North Mining Limited

Northparkes Mines

Section 75W Submissions Report

July 2009

Noise Sources - Receivers

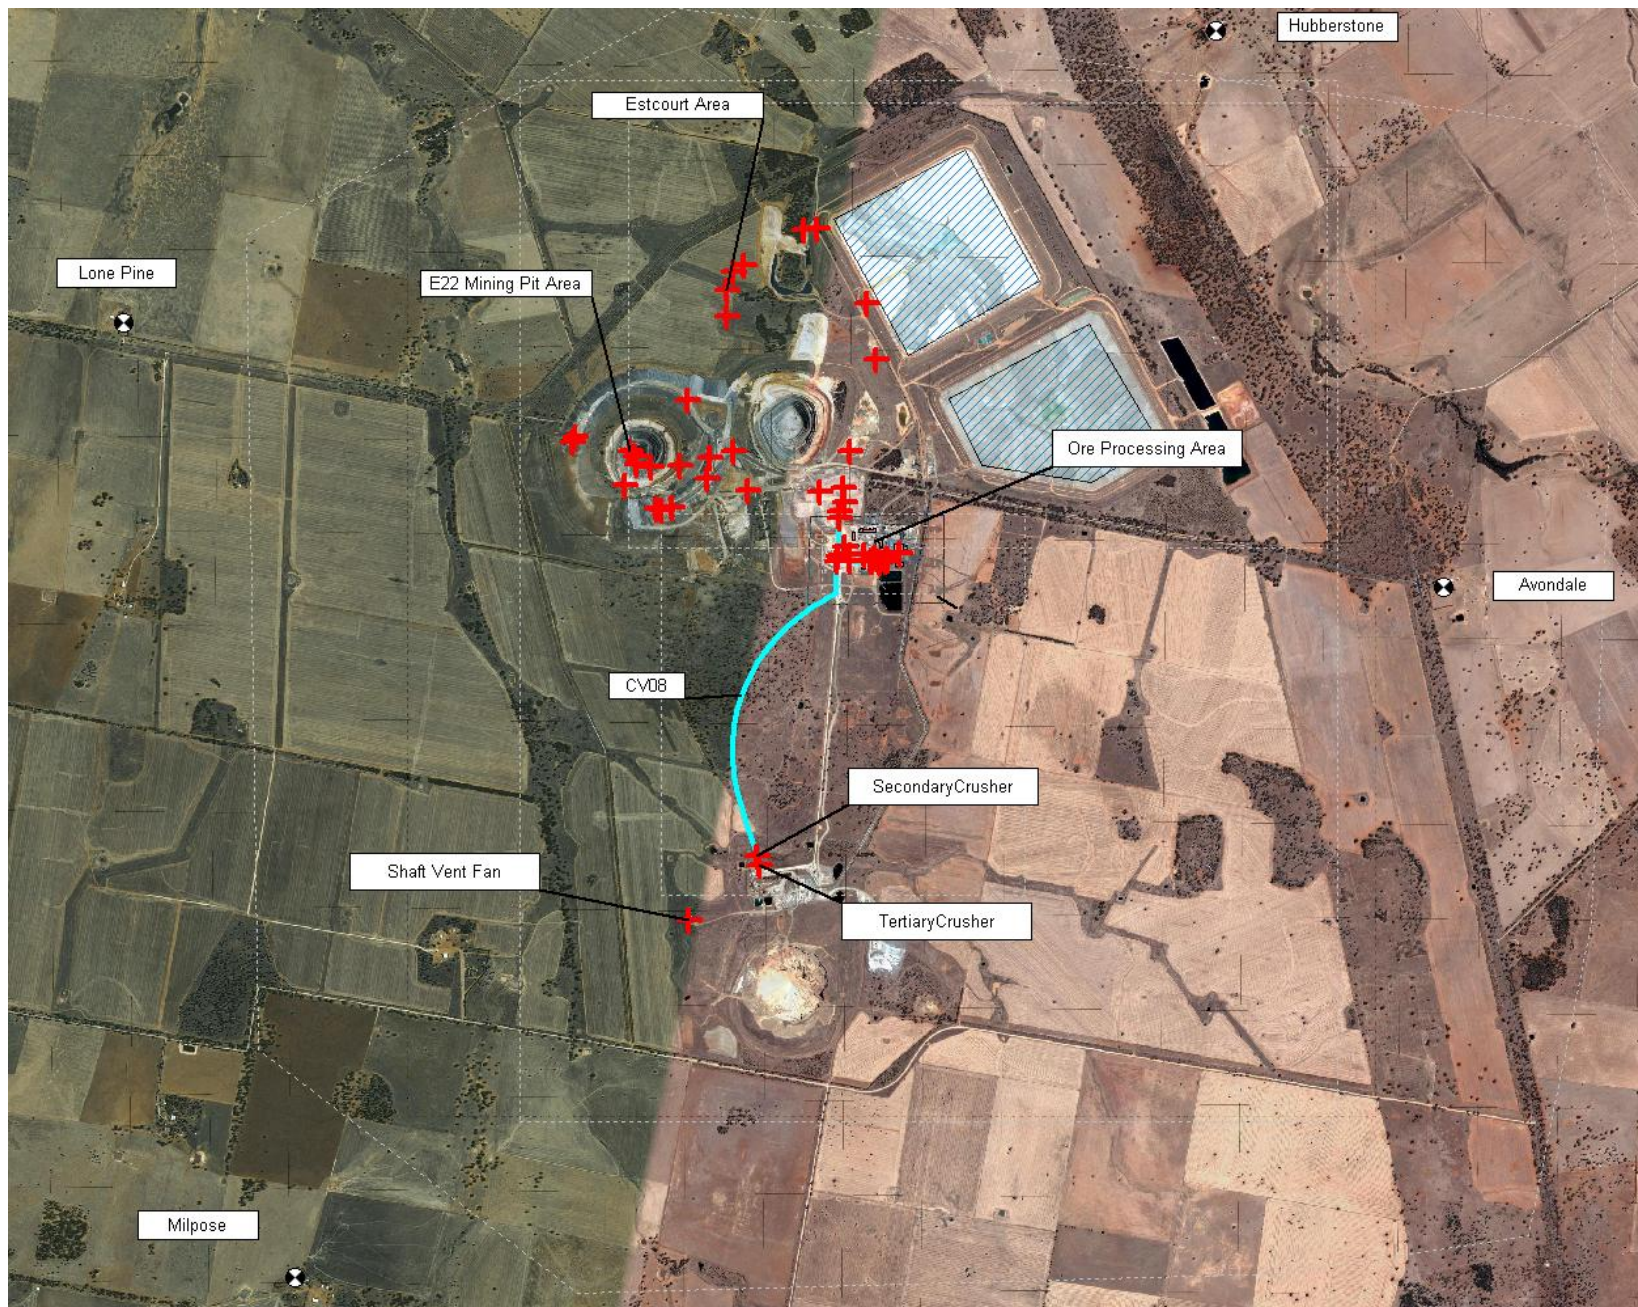
- 3. NPM must provide a figure in the Noise Impact Assessment (NIA) detailing the mine site and the surrounding topography out to as far as the nearest affected receivers with the location of mobile and stationary plant and equipment in the noise model superimposed.*

3. Figures are provided in Appendix B.
4. All references in the EA to DECC Construction Noise Guidelines were noted as "Draft for consultation".
5. The original NIA used the Draft Construction Noise Guideline because the Estcourt TSF construction is not part of the typical operational noise for NPM and therefore was not considered as operational noise. The NIA was reviewed against both the Draft Construction Noise Guideline and chapter 171 of the DECC Environmental Noise Control Manual (ENCM). This revealed that the construction noise criterion is identical, i.e. background + 5dB = 35 dB(A). Therefore the criteria would remain the same if the ENCM was used instead of the Draft Construction Noise Guideline as required by DECC.

Figure 1 Part of Water Management Plan Figure 7 showing TSF 3 groundwater monitoring points

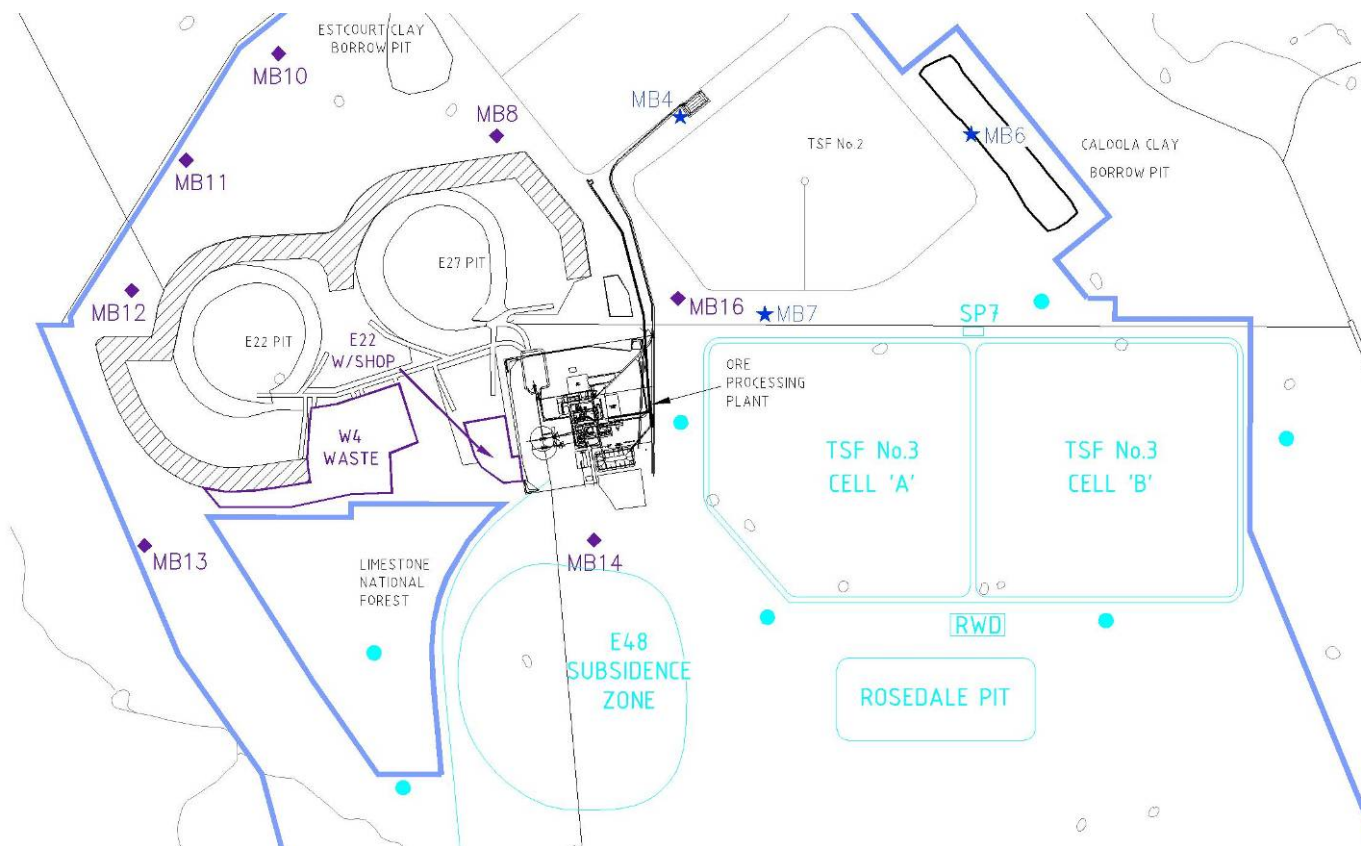
The EA should also provide details of the number and locations of proposed groundwater monitoring bores surrounding TSF 3 to detect any leakage and further details of the proposed monitoring program.

The number and locations of proposed groundwater monitoring bores surrounding TSF 3 and the water monitoring program are detailed in NPM's Water Management Plan (WMP) that was prepared in consultation with DECC in August 2007. Extracts of the WMP showing monitoring locations, parameters and frequencies are provided in Appendix C.
